Project	IEEE 802.16 Broadband Wireless Access Working Group < http://ieee802.org/16 >
Title	Clarification of H-ARQ Operation with Reduced AAS Private Map
Date Submitted	2005-01-24
Source(s)	<p>Inseok Hwang, Jaehee Cho, Seungjoo Maeng, Jaeho Jeon, Soonyoung Yoon, Samsung Electronics Co. Ltd. is91.hwang@samsung.com</p> <p>Ran Yaniv, Tal Kaitz, Danny Stopler, Naftali Chayat, Vladimir Yanover Alvarion Ltd. ran.yaniv@alvarion.com</p> <p>Dave Pechner, Doug Dahlby, Todd Chauvin ArrayComm Inc. dpechner@arraycomm.com</p>
Re:	Recirculation of P802.16 REVe/D5a
Abstract	Some clarification and modification of Reduced AAS private map is proposed for reliable H-ARQ operation.
Purpose	Adoption of suggested changes into P802.16e/D6
Notice	This document has been prepared to assist IEEE 802.16. It is offered as a basis for discussion and is not binding on the contributing individual(s) or organization(s). The material in this document is subject to change in form and content after further study. The contributor(s) reserve(s) the right to add, amend or withdraw material contained herein.

Suggested text changes to 16.e standard

Fig. 1. Reduced AAS Private MAP Operation

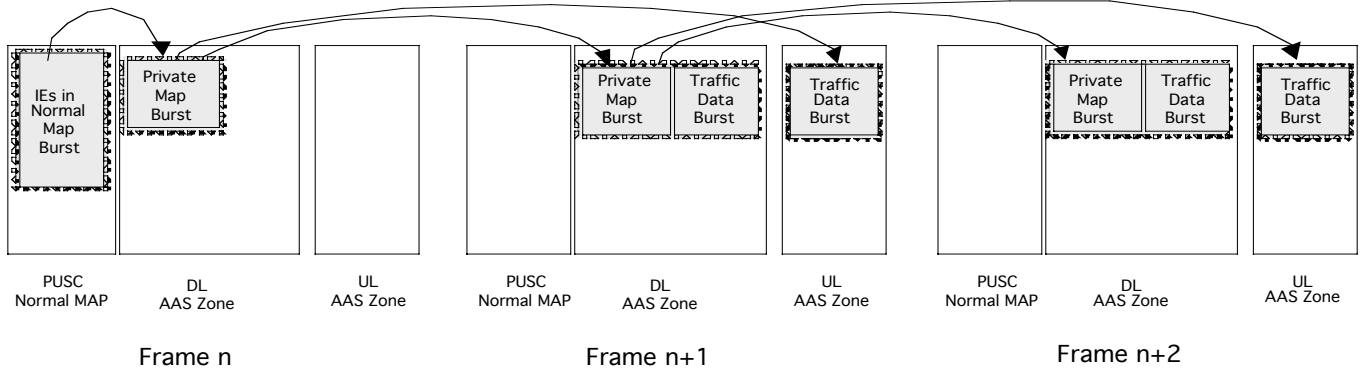
The reduced AAS private map concatenates MAP and DL data burst and apply the coding and modulation to the concatenated burst, which is designed to exploit beam-forming gain and signaling efficiency of bandwidth allocation. However, clarification and modification of reduced AAS private DL map is needed for reliable H-ARQ operation and MAP signaling. The H-ARQ operation allows the retransmission of coded symbols, which imply that each transmission cannot be decoded correctly. Consequently, the reduced AAS_private_map containing H-ARQ signaling information should be encoded separately from DL traffic burst itself to exploit the advantage of H-ARQ operation.

Fig. 1 illustrates the reduced AAS Private MAP operation when reduced AAS Private MAP points the allocation region for next frame. In the figure, dashed box denotes the absolute allocation region and (n+1)th frame.

To enable separate modulation and coding, the following fields are added in Reduced_AAS_Private_DL_MAP message. Note that when ‘Separate MCS Enabled’, DL data burst a reduced_AAS_Private_MAP including all AAS configuration change information, bandwidth allocation, H-ARQ signaling information are encoded separately.

- ‘Separate MCS Enabled’ to indicate separate coding for reduced AAS Private Map and DL data burst
- ‘Slot Duration’ to specify number of slots for transmitting reduced AAS_Private_MAP
- ‘DIUC and Repetition Coding Indication’ for reduced AAS_Private_MAP

Since the reduced AAS_Private_DL_MAP specifies the two-dimensional region for reduced AAS_Private_MAP and DL data burst, the data burst are transmitted through the remaining slots after assigning slots for reduced AAS_Private_MAP.
